BID # 26-006

PHASE 2 SHADE STRUCTURES – 5 SITES
VICTOR ELEMENTARY SCHOOL DISTRICT
VICTORVILLE, CA

July 6th, 2026

ADDENDUM – 01

G-1.1

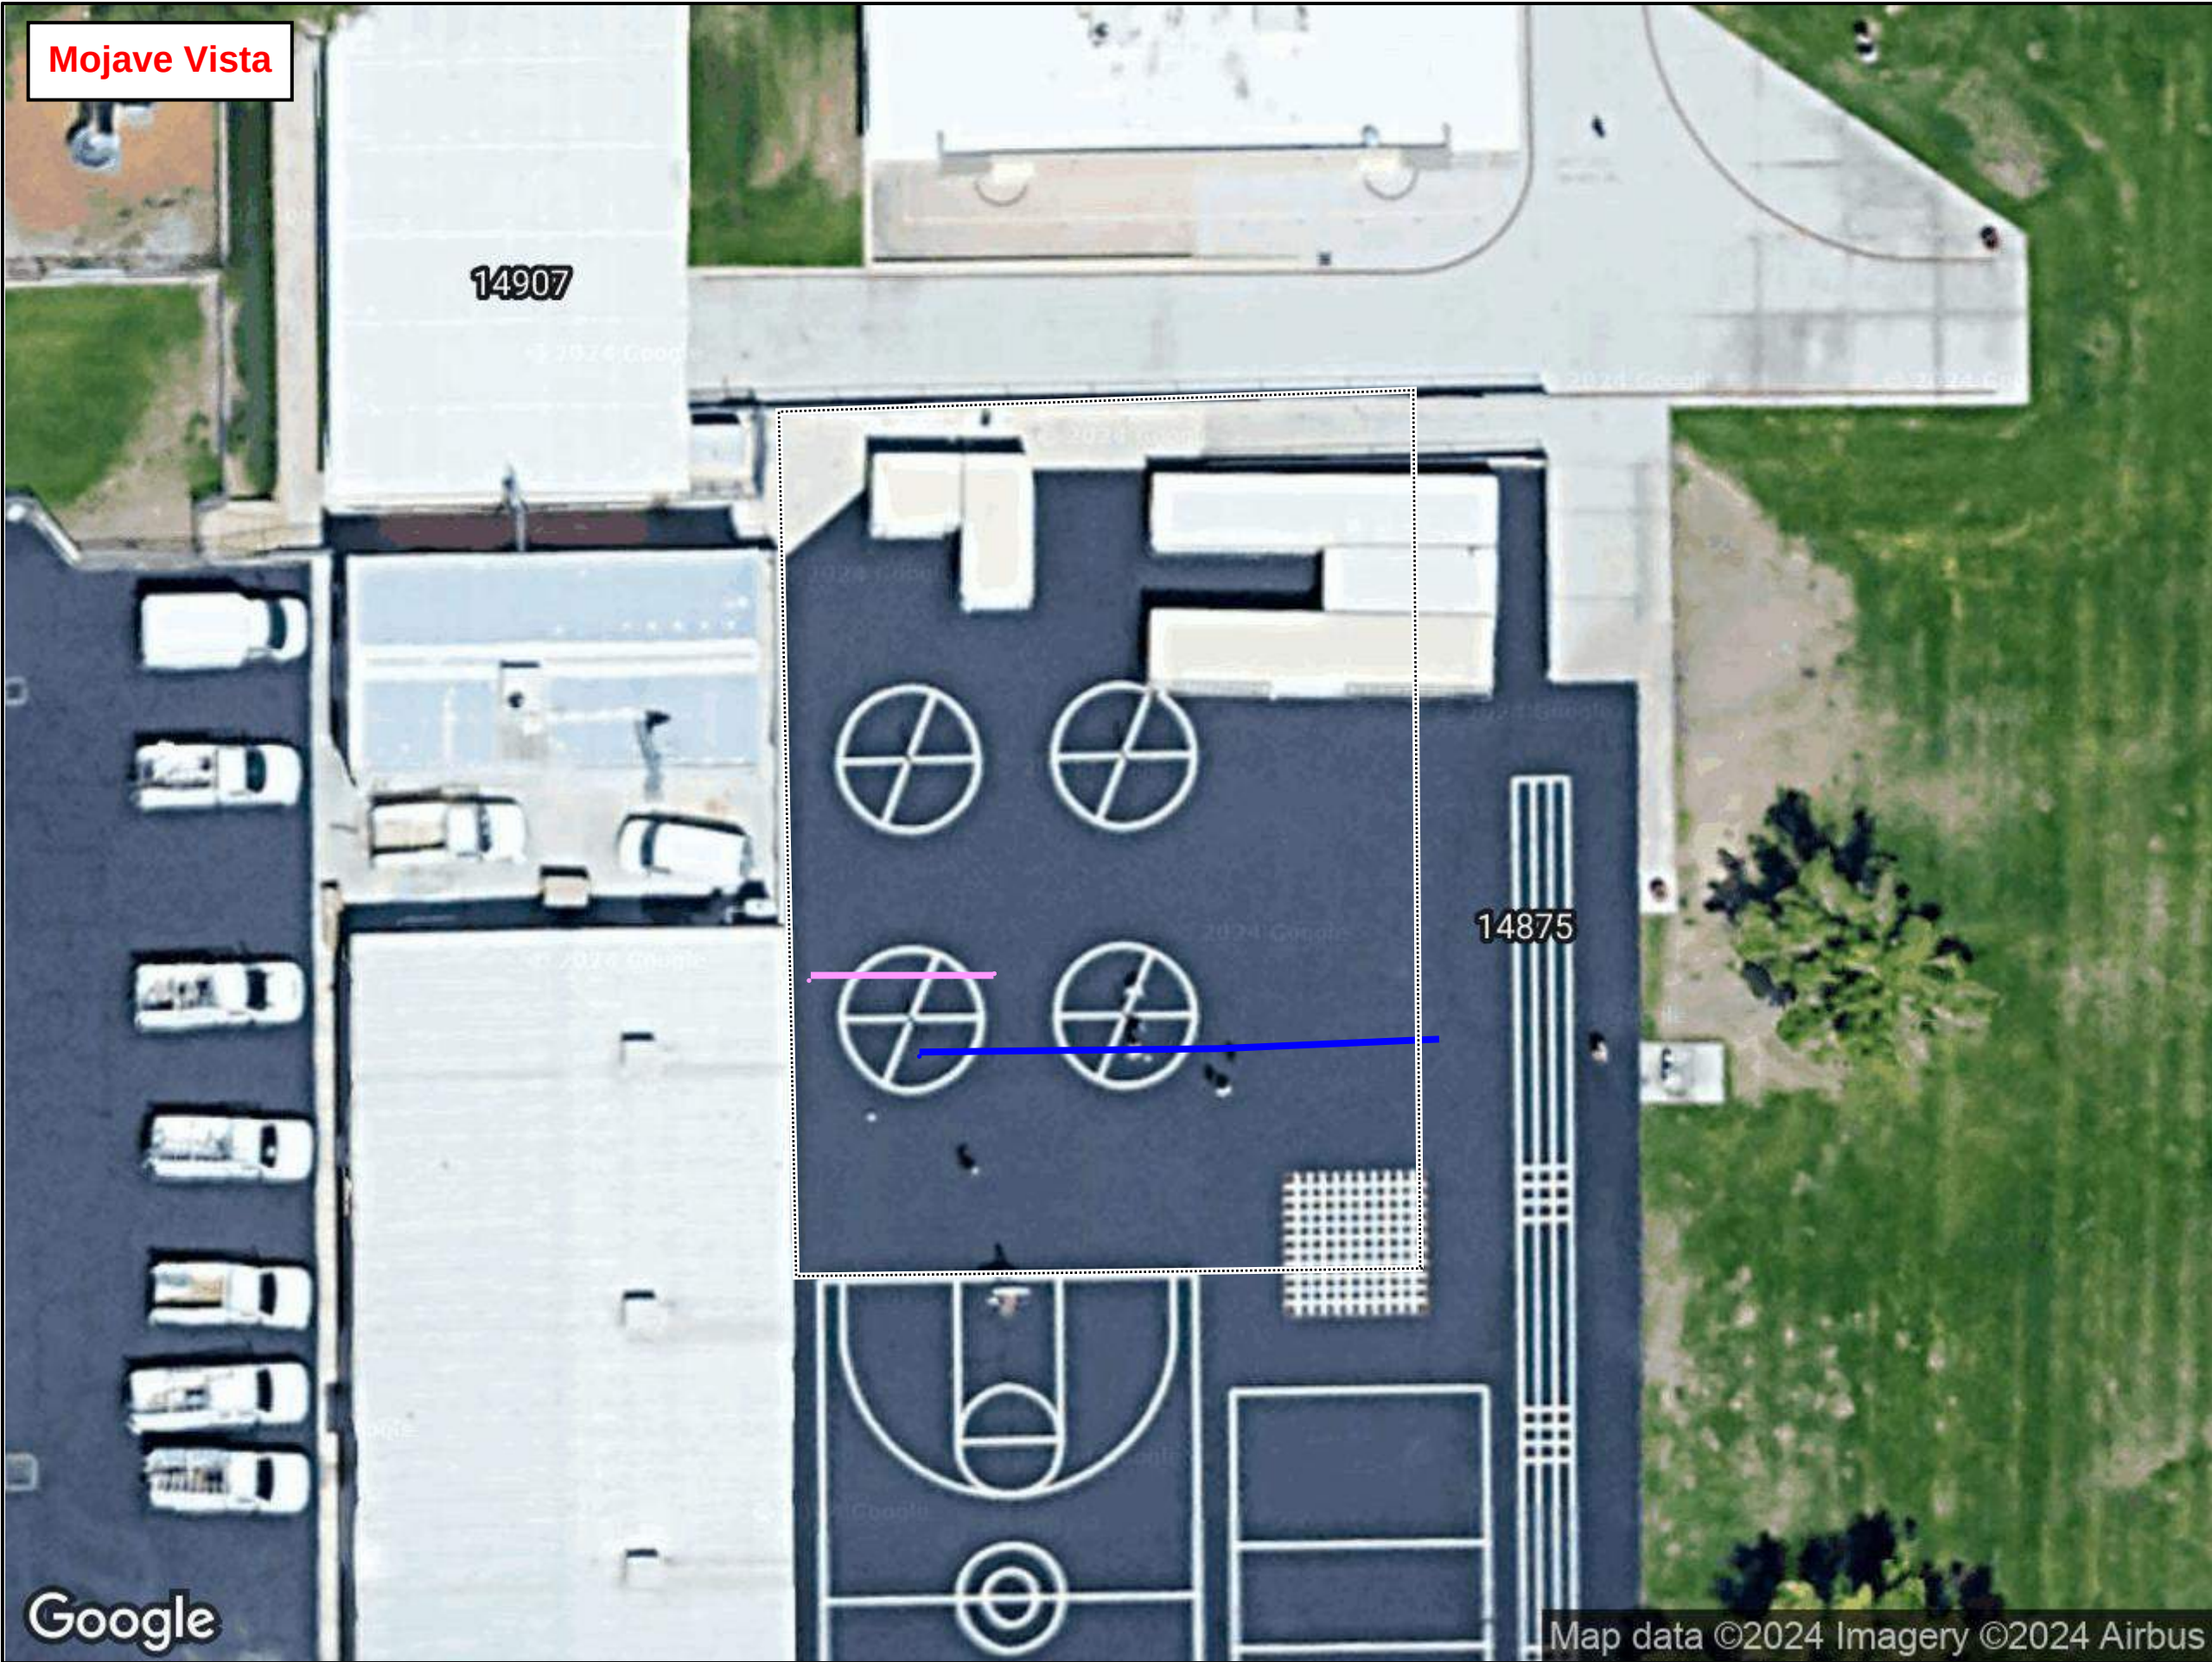
6. CONFIRMATION, DESCRIPTION AND LISTING OF DOCUMENTS:			
For addenda, revisions, or CCDs: CHECK THIS BOX ☒ to confirm that <i>all</i> post-approval documents have been stamped and signed by the Responsible Design Professional listed on form DSA 1: Application for Approval of Plans and Specifications for this project. (For Deferred Submittals, refer to IR A-18: Use of Construction Documents Prepared by Other Professionals, and IR A-19: Design Professional's Signature and Seal (Stamp) on Construction Documents, when applicable, for signature and seal requirements.)			
Provide a brief description of construction scope for this post-approval document (attach additional sheets if needed): Revised new POT connection to existing POT 04-123445 (04-123445 is closed as of 8/26/25). Curb with guardrail added & concrete pad extended as noted (dimensions added to locate pad), and legend information updated.

List of DSA-approved drawings affected by this post-approval document: G-1.1

Paving Detail Sheet

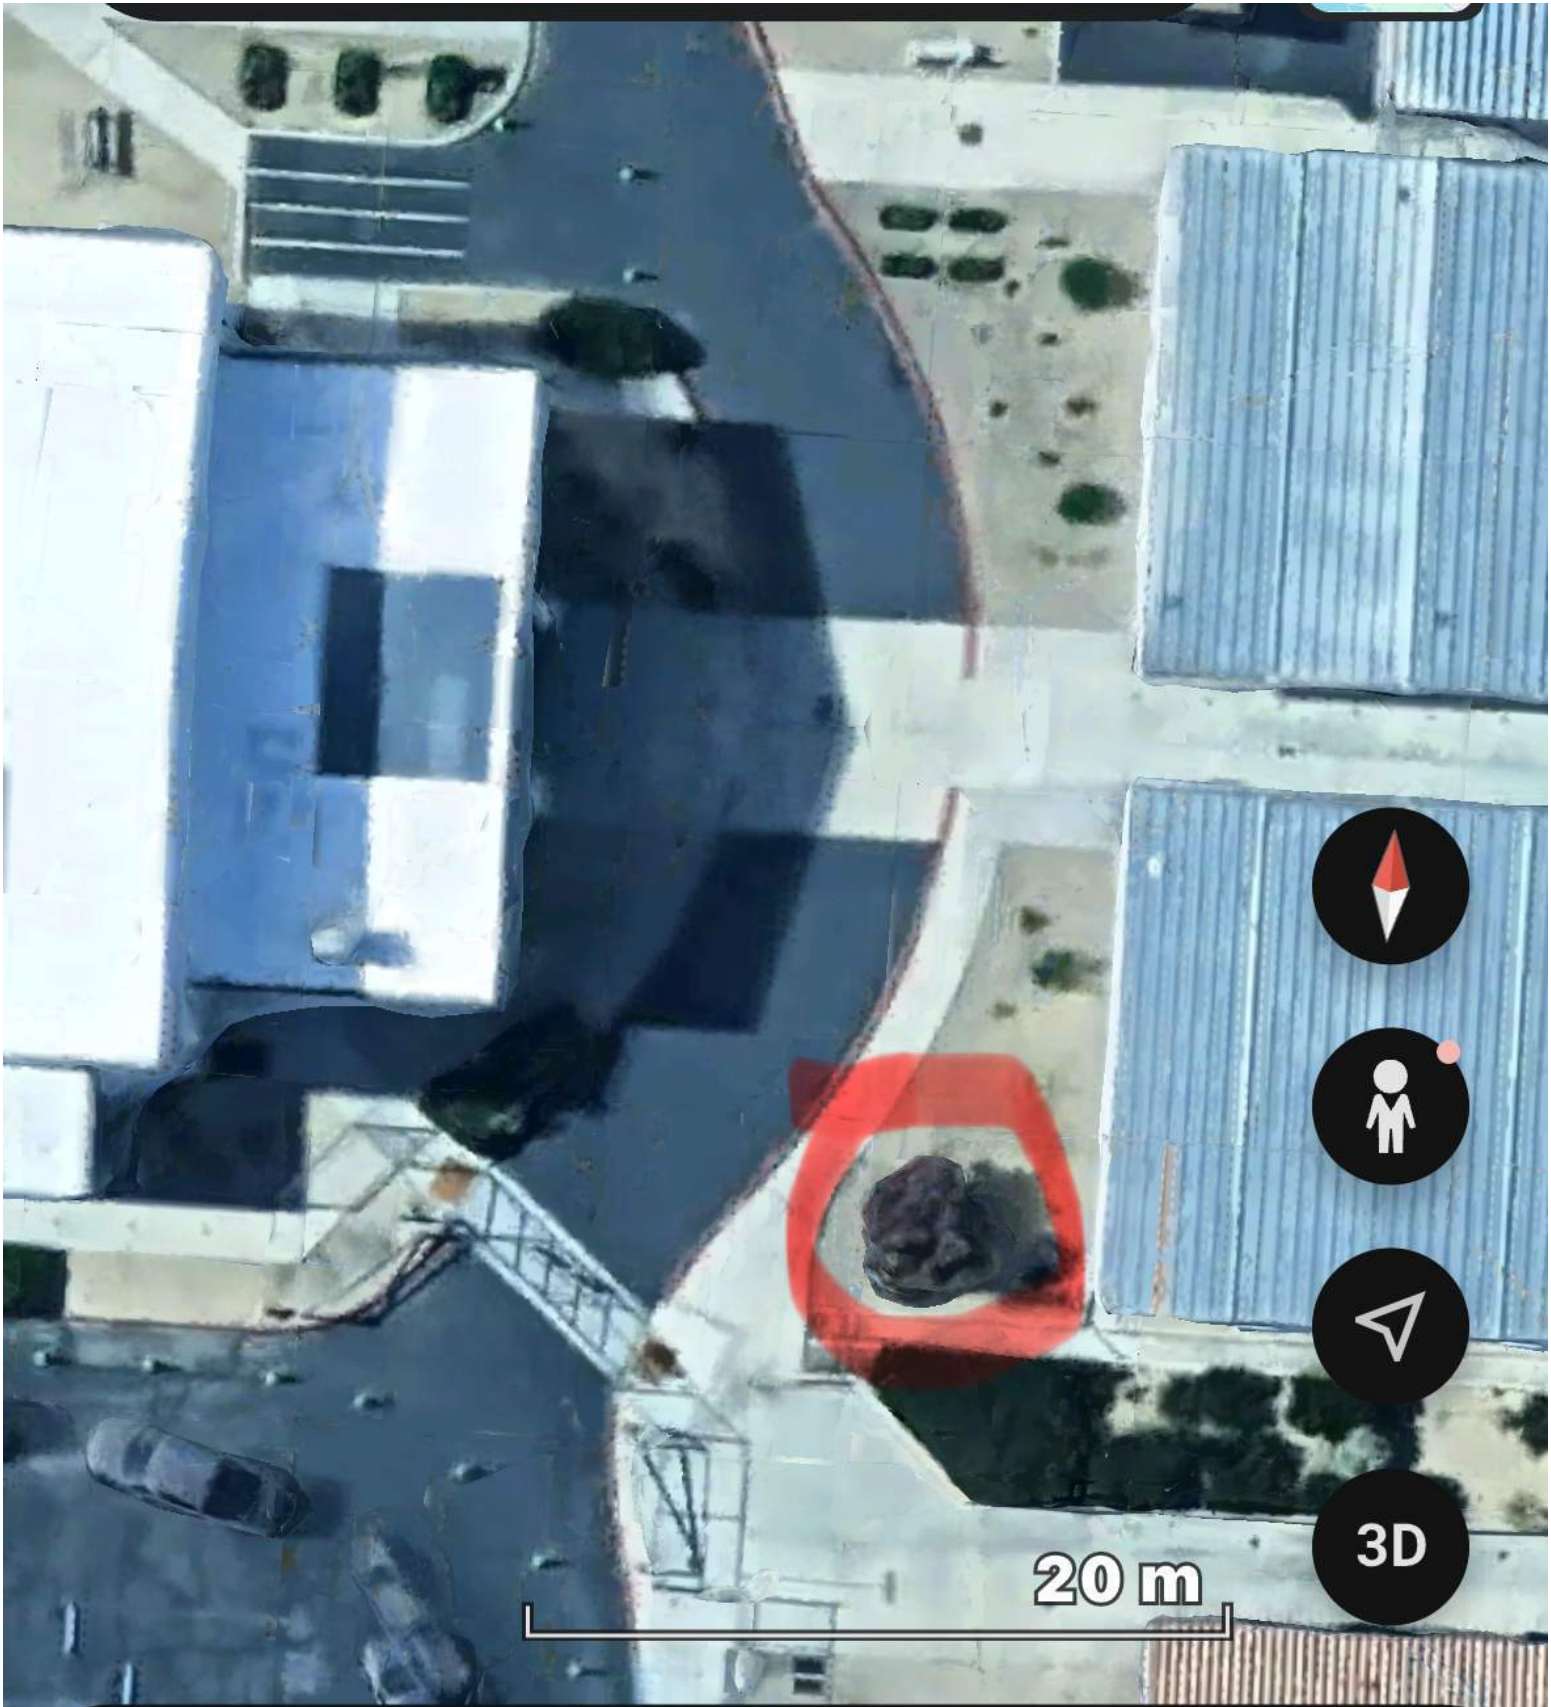
- ITEM NO. 12 Question: The Bid Documents do not include details for the new concrete pads or asphalt grind and overlay work. Please provide the applicable construction details.

- Response: Refer to the attached Paving Detail Sheet included with this Addendum for the required details applicable to the new concrete pads, asphalt grind and overlay, new asphalt pavement, concrete pavement sections, slab connections, control joints, thickened slab edge details, and related paving improvements. The Paving Detail Sheet shall be incorporated into and made part of the Contract Documents.

Tree Relocation Exhibit

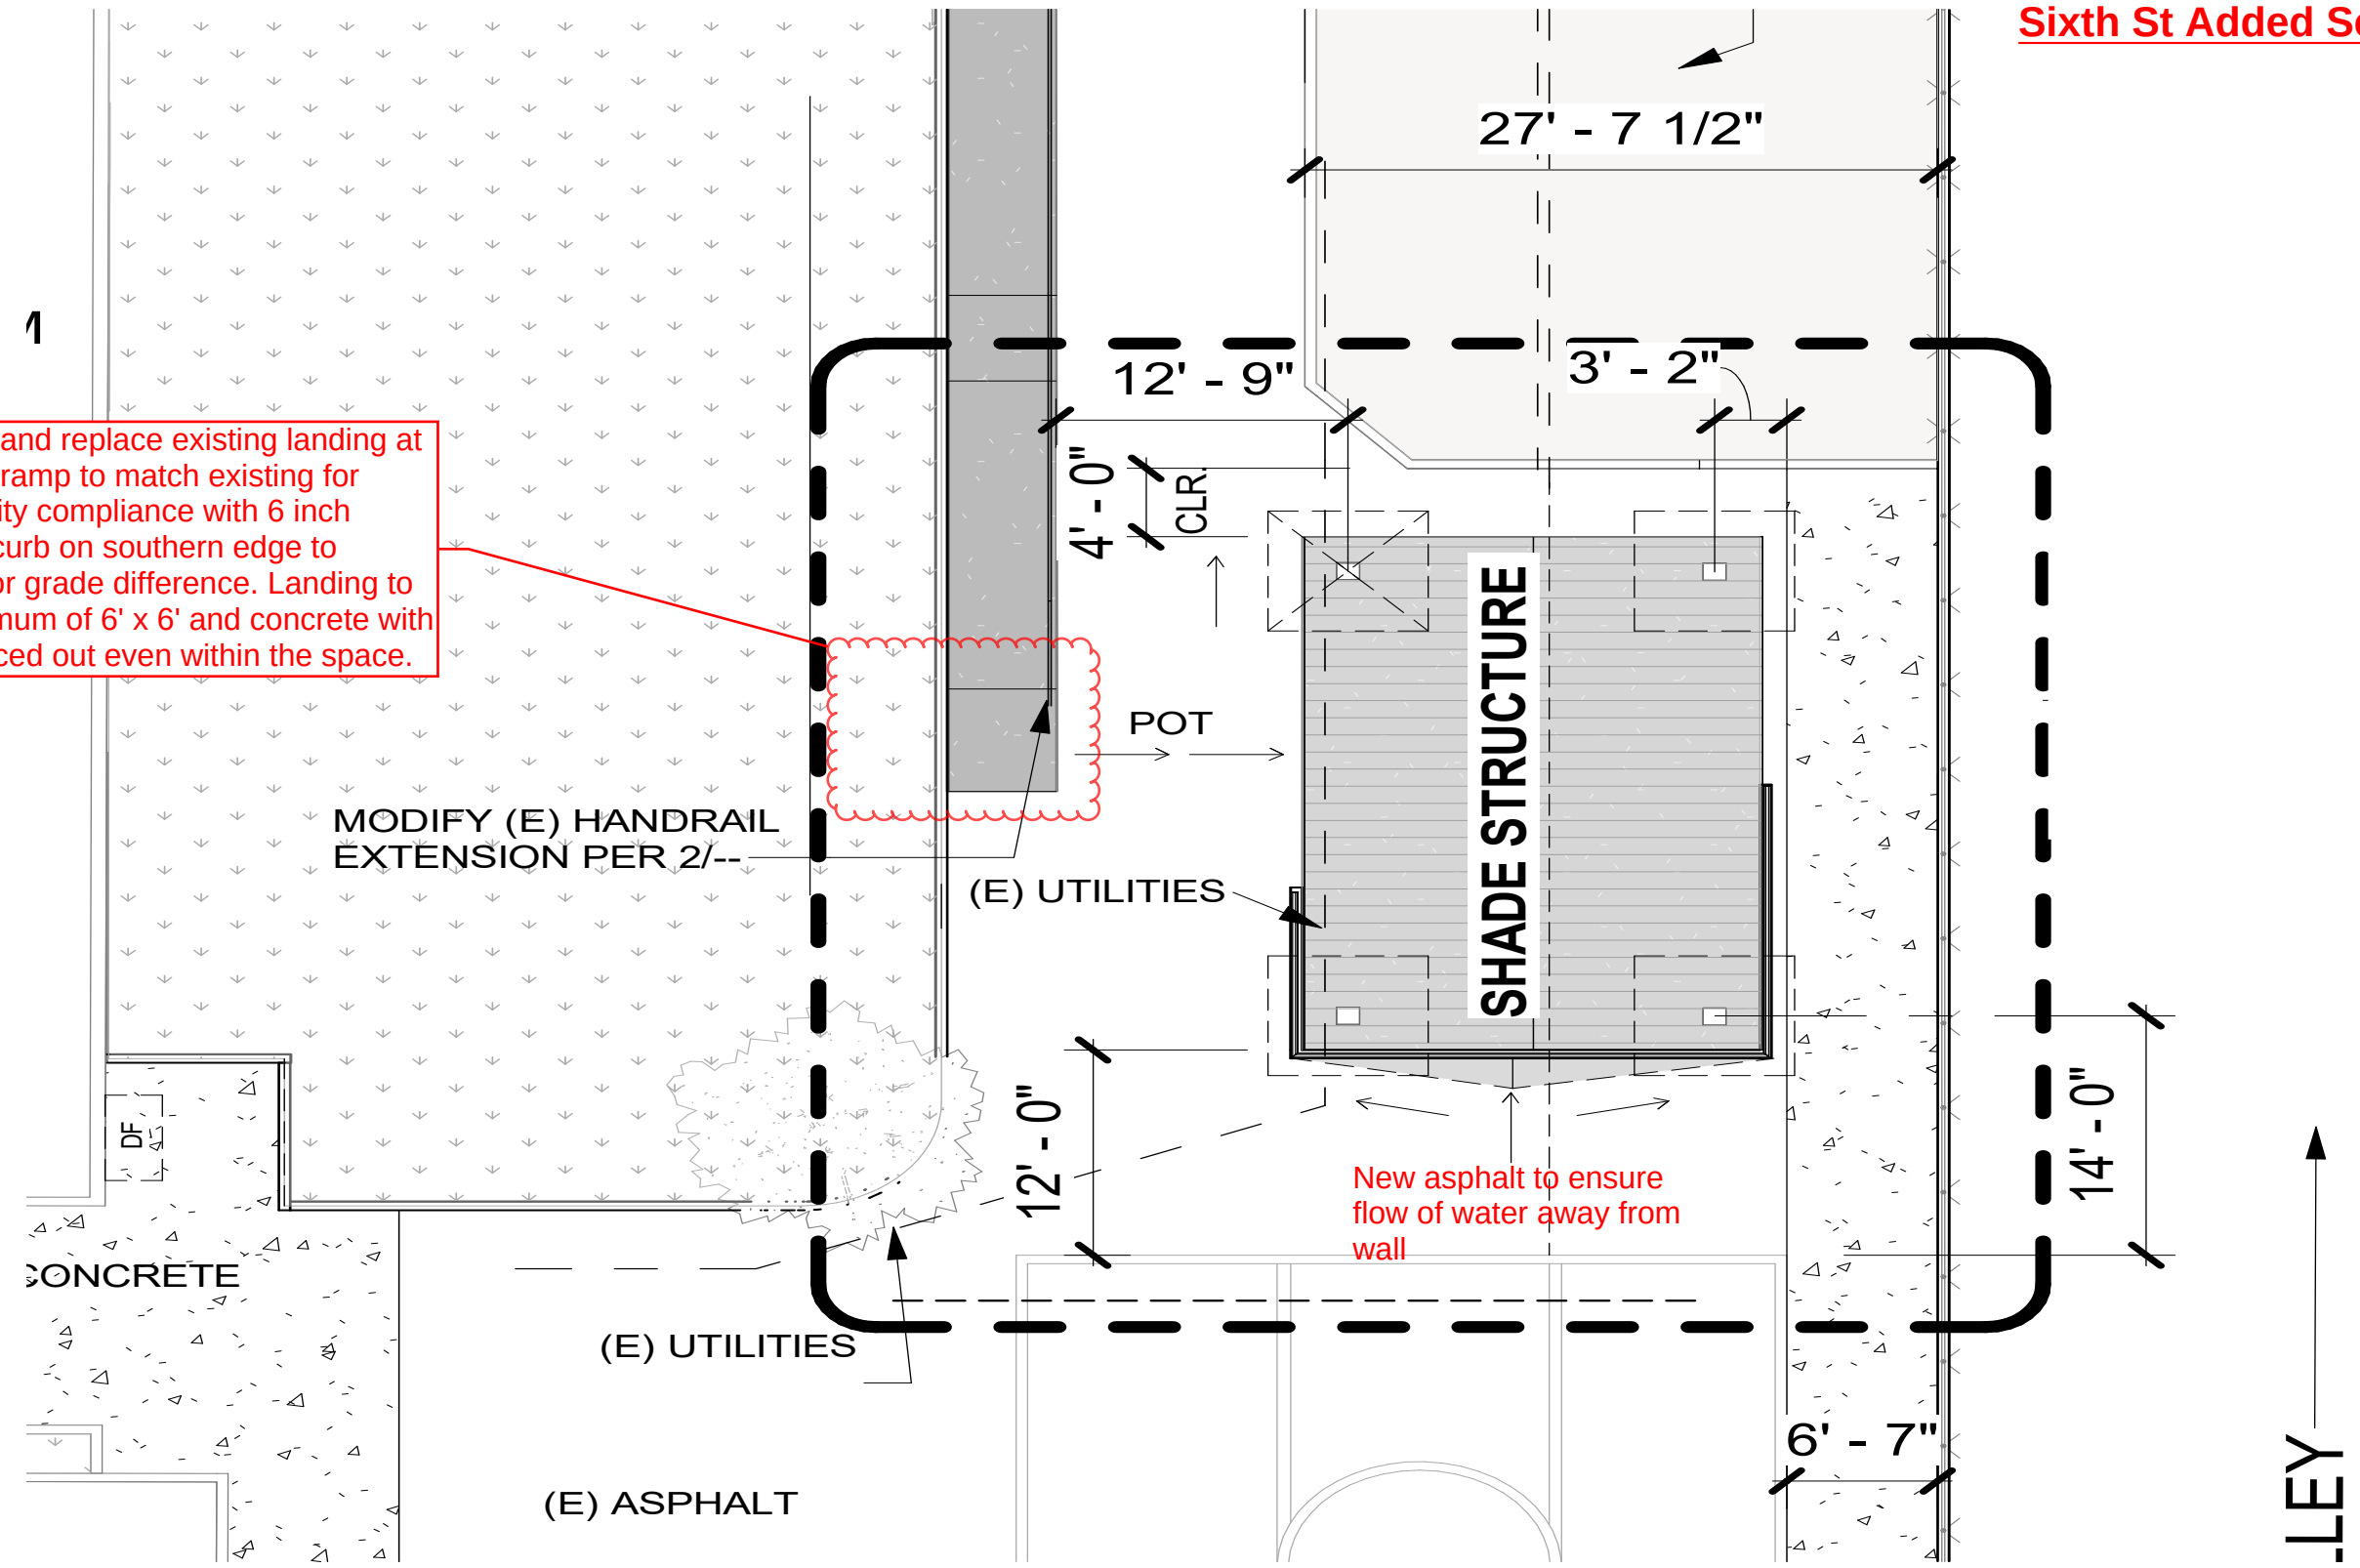
- ITEM NO. 14 Question: Existing trees and planters are located within the proposed shade structure footprint. Please confirm how the existing trees and planters are to be handled and provide the required relocation location(s), if applicable.

Response: One (1) existing tree located within the proposed shade structure pad shall be relocated to the area adjacent to the MPR Building, as shown on the attached Tree Relocation Exhibit. Two (2) existing planters located within the shade structure footprint shall be removed and demolished.
